Request for additional information in the matter of:

Project Number: Glob-SAR-Tablet-5626 **Test/Analysis Date:** October 14th/18th 2011

FCC ID: Z4J-2001101-001A **IC ID:** 9939A-2001101001A

Subject: Tablet Computer device

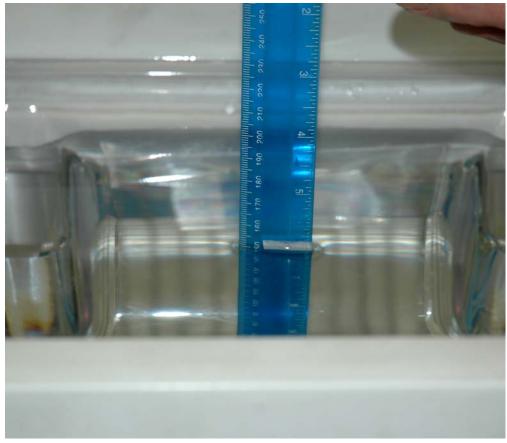
a. Tissue Simulation Fluid: Please provide a photo that shows that the Tissue Simulation Liquid in the body phantom was at least 15 cm deep. Include a ruler in the liquid.

Pictures follow:

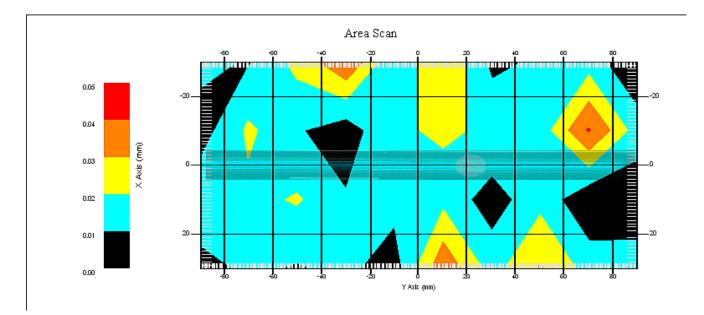
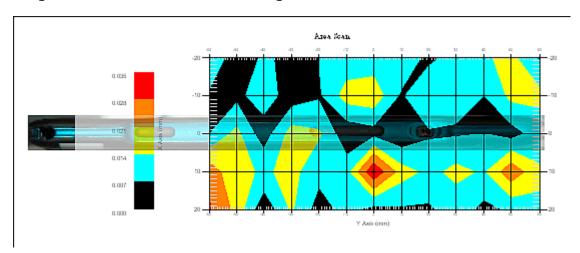
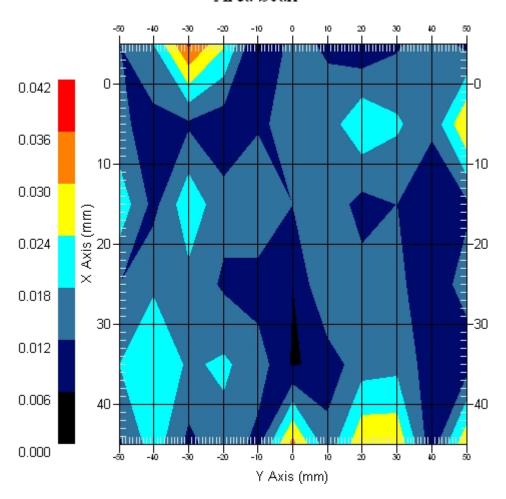
b) Page 5: Please explain what plots (page number & measurements) these "Additional SAR Measurements" relate to. The value at the end marked SAR, is that 1g SAR W/kg?

The value for that marked SAR is 1g SAR W/kg. Future reports will be so labeled, and we thank you for pointing out this improvement. The purpose of the "additional" results was to pinpoint the areas of greatest SAR, in the manner of a survey in preparation for the actual SAR test so testing would concentrate on generating the most conservative results. As such none of the plots in the report relate to these additional results. However, for your information the plots follow.
